**NRC Feedback on “KHNP’s Draft Revised Response to RAI 129-8085, Question 3.8.1-1”
(Draft Response Provide 2/19/16)**

The staff evaluated the draft response to Question 3.8.1-1 and noted the following:

Figure 1. Locations for Transient Displacement (Hydrodynamic Load, Time History Analysis)

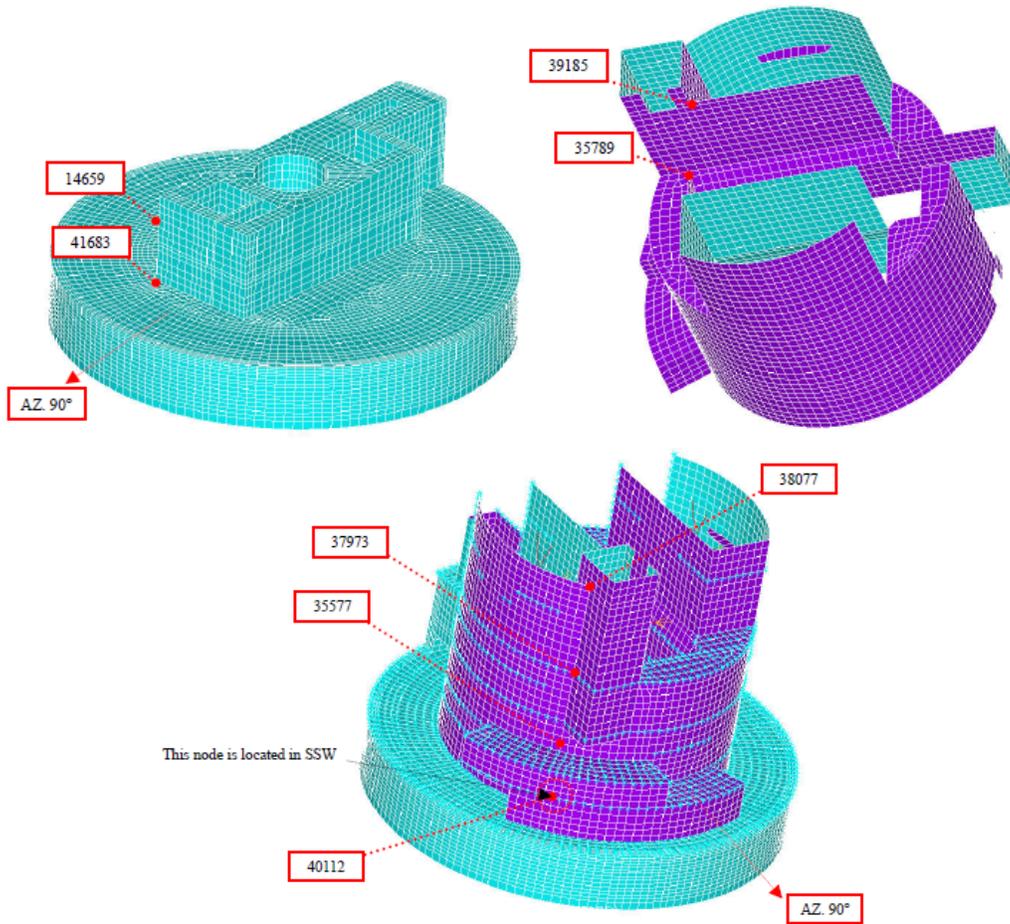
The remaining paragraphs of the response, including the response to Question 03.08.03-1 of RAI No. 208-8245, do not adequately demonstrate that there will be no overall building response in terms of member forces and building response spectra. The RAI response indicates that the hydrodynamic pressure load is a short transient pressure time history, the period of the POSRV discharge load is very short, and the load rapidly decreases in magnitude. This type of hydrodynamic pressure time history is similar to safety relief valve transients in other nuclear power plants which have shown in some cases to cause significant loading on the overall building response and response spectra. Therefore, the applicant is requested to provide further justification to address this item.

With regard to the dynamic overall building response caused by POSRV loads, the additional hydrodynamic load analysis, which is time history analysis (refer to Table 1 of Question 03.08.01-15 of RAI No. 249-8323), has been carried out. In this analysis, the transient displacements of primary and secondary shield wall (PSW and SSW), which will be directly influenced on POSRV load because of entire structure (PSW, SSW, IRWST), were calculated. The locations for transient displacement were selected within the influence region of POSRV loading as shown in Figure 1. The maximum transient displacements of PSW and SSW are also described in Table 1. As shown in Table 1, on every direction, the maximum transient displacement is less than 0.0036 inch (0.091 mm). Figure 2 shows the Floor Response Spectrum (FRS) of PSW (EL. 100'-0", EW) by POSRV load. And the comparison of spectral acceleration between POSRV and seismic (SSE) loads (EL. 100'-0") is shown in Table 2. The spectral acceleration by POSRV is less than 9 percent of that by seismic load. Therefore, it can be judgeable that the structure response caused by POSRV load is negligible to overall building except for local design of IRWST wall for POSRV pressure load.
